ADMINISTRATIVE APPROVAL (LS) ADD2013-00180

ADMINISTRATIVE APPROVAL
LEE COUNTY, FLORIDA

Project: **Red Roof Inn Lot Split**
Case: **ADD2013-00180**
STRAP: **11-44-24-00-00017.4A8B**

Attachment "A"

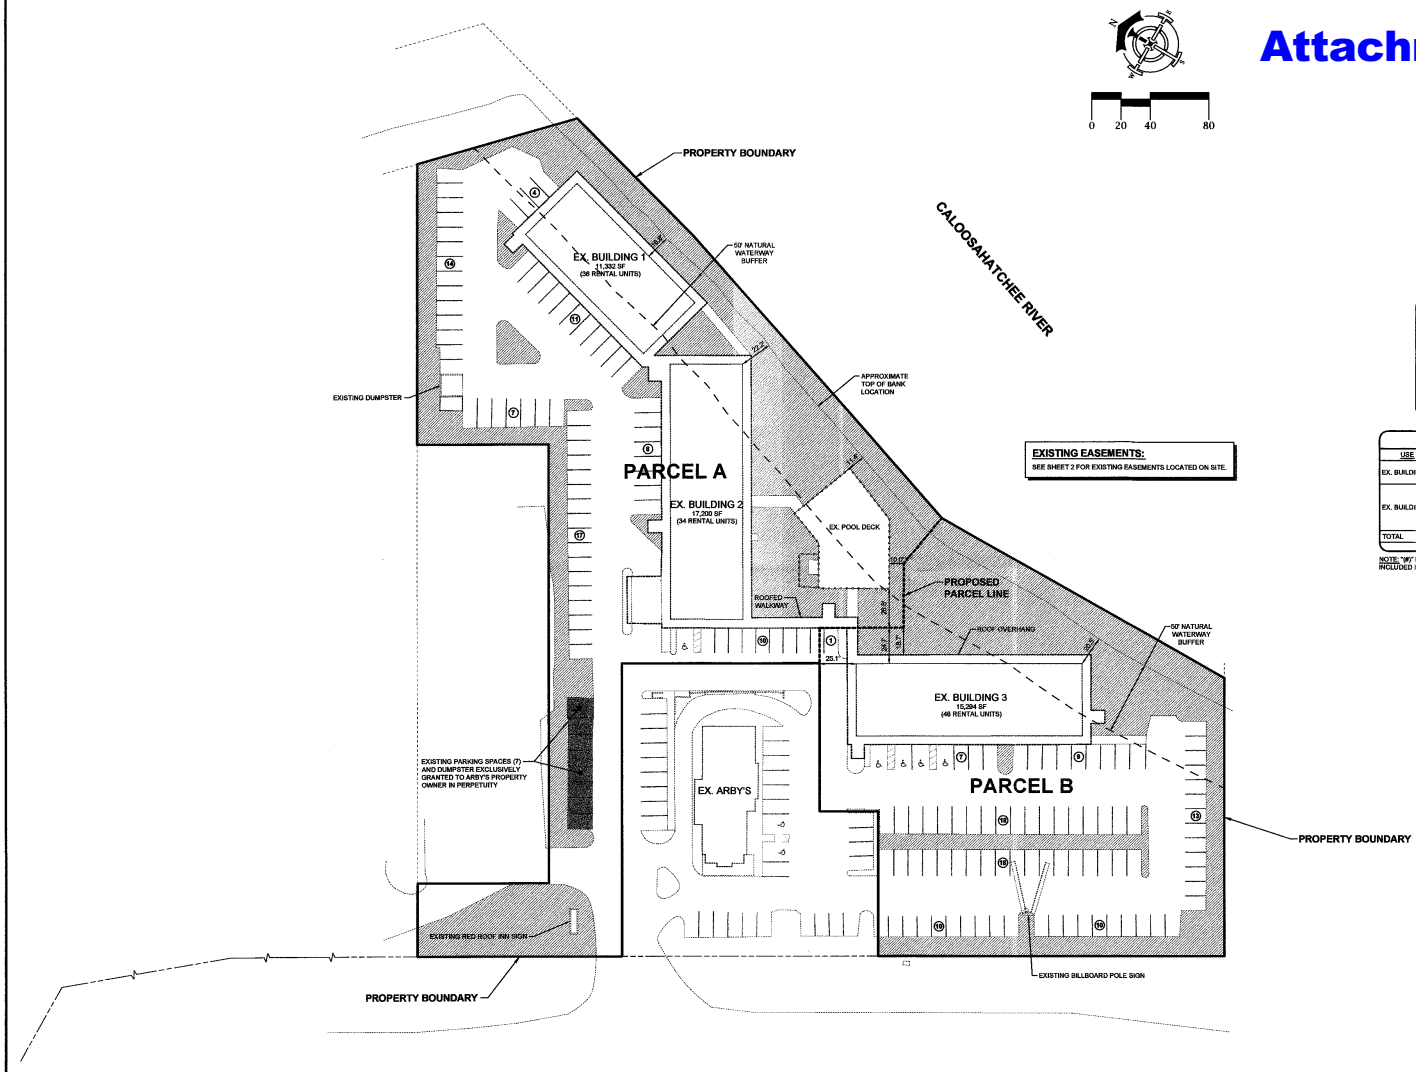
5. LDC Section 10-416(d)(9) which requires a natural waterway buffer of 50 feet to a width as demonstrated on the attached site plan to bring existing buildings into compliance.

The applicant is requesting to have the natural waterway buffer reduced from 50' to a width as demonstrated on the attached site plan to bring the existing buildings into compliance. There are no changes being proposed to the buildings at this time however the current site does not provide a 50' buffer to the water body.

The second deviation is from LDC 10-416(d)(9) which requires a 50' wide natural waterway buffer adjacent to the Caloosahatchee River. The applicant is requesting that the existing setbacks for the existing buildings, parking, and pool area be allowed to remain. The site was developed prior to this code section being adopted. Per the site plan, the site does provide the 50' natural waterway buffer width in a couple of locations. There is an existing mangrove fringe along the river which per the original development plans is to remain undisturbed. No new structures are being proposed. Given that the site is existing, was developed prior to these code sections being adopted, an existing mangrove fringe adjacent to the Caloosahatchee River which is to remain undisturbed, and no new structures are being proposed at this time; ES staff recommends approval of the requested buffer deviations. The site landscaping must remain in compliance with the approved landscape plan per development order 84-04-012.00D. Any future

1. The development must be in substantial compliance with the proposed Site Plan per Attachment “A”.

The site landscaping must remain in compliance with the approved landscape plan per development order 84-04-012.00D. The existing structures and improvements may remain within the 50' natural waterway buffer. Any future structures or improvements must comply with the land development code natural waterway buffer and all other landscaping requirements at time of local development order review.
